Delegated Report

Householder Planning Application

Planning Application No: 20250306

Description: Application for retrospective hardstanding area in the front garden, and proposed creation of a vehicle crossover.

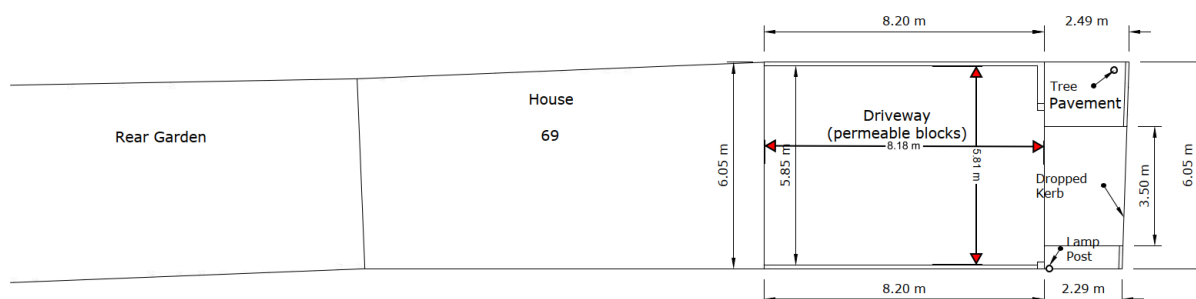
The development would create space for off-street parking. Case officer measurements are indicated in red and black below:

There are concerns with the proposal due to the height of the wall (which at 1.01m exceeds the 600mm KCC requirements), the lack of pedestrian visibility splays, and the proximity to the junction. In addition, it is noted that the site is within close proximity to a school and new care home. The overall visibility and highways concerns are considered to be detrimental to highways safety.

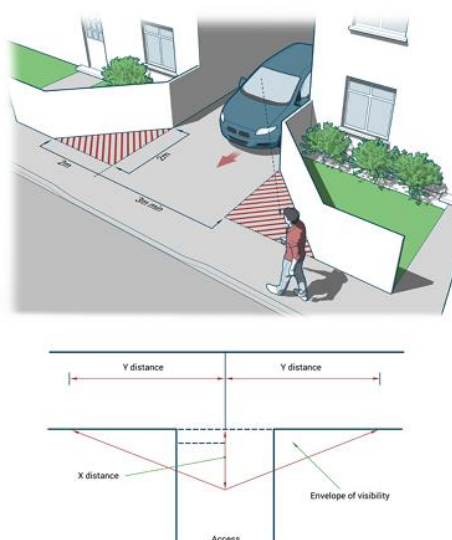
As aforementioned above, planning permission is required for the development. SPG 4 – KCC Parking Standards (2006) and Gravesham's Householder Extensions/Alterations Design Guide (2021) sets out that front garden parking must be designed to avoid cars overhanging the pavement. Car parking spaces a minimum of 2.50m wide (2.70m where spaces adjoin an enclosed boundary) and 5.00m deep should be provided. The plans indicate there would be sufficient space for two cars.

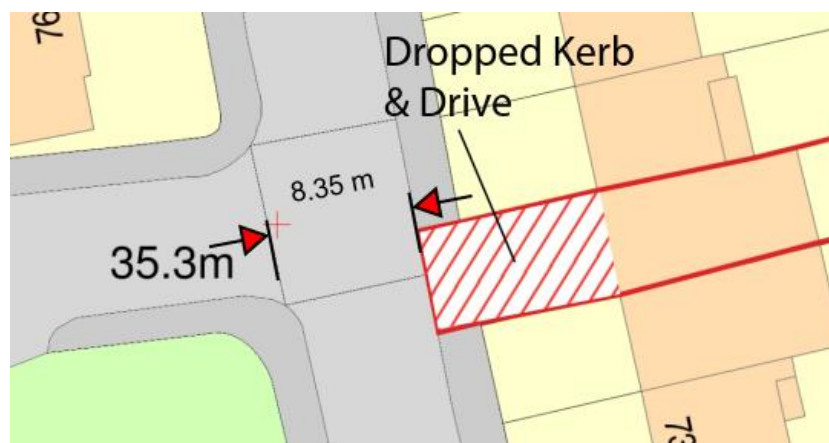
Footway Visibility - For pedestrian visibility, **a splay of at least 2m x 2m with a maximum height of 0.6m from the back of footway will be required.** Greater visibility may be required on faster and busier roads and therefore your application will be assessed on site specific criteria.

There should be no obstruction to visibility (walls, vegetation, fencing, etc) over the height of 0.6m above footway level.
